Subject: FW: H01-1216-16: 230 Barrier Bank, Cowbit
Attachments: Mimecast Attachment Protection Instructions; 2479 - BB - 02B - Block Plan.pdf

Subject: H01-1216-16: 230 Barrier Bank, Cowbit

Dwg No **2479 / BB02B**

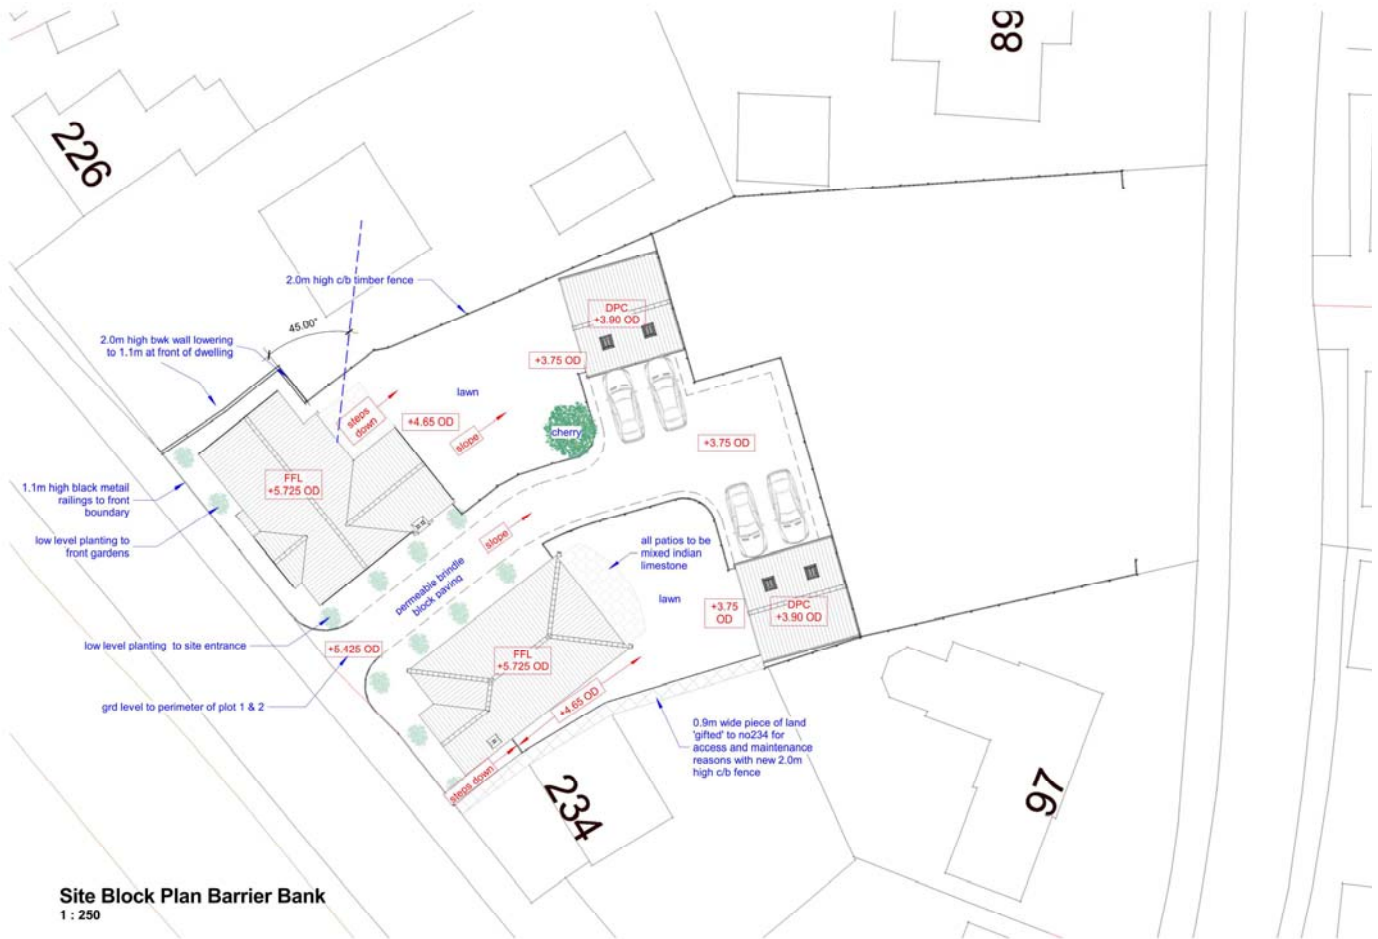
I have been looking at the above application with a view to sending it to the Chairman's Panel, but have a few issues with the proposal on plot 1 with regards to overlooking of upper floor windows in the two storey extension to the side of number 228.

The proposed window for bedroom 3 appears to be very close to the windows on the front elevation of 228 Barrier Bank, which may be an overlooking concern. Could you comment on this please?

From dwg. no. 2479/BB05, there appears to be a FFL of 4.469 and the FFL on dwg. no. 2479/BB02A for the proposed is 5.725 OD. Could you clarify the difference in FFL from the existing to the proposed, as the elevations seem to show a different picture.

I don't agree that Bed 3 window will have any overlooking issues with their first floor windows due to the separation and position of plot 1. I believe it will be physically impossible to have any overlooking. I have attached a quick sketch showing the 45° angle rule from bed 3.

FFL 4.469 is for the poultry sheds to the rear and not the actual extg house FFL, which is 4.890. It is proposed to lift the FFL to approx. 150mm above path level (5.725) but this can be lowered to suit any of your concerns to gain permission. Let me know if you want me to lower the FFL
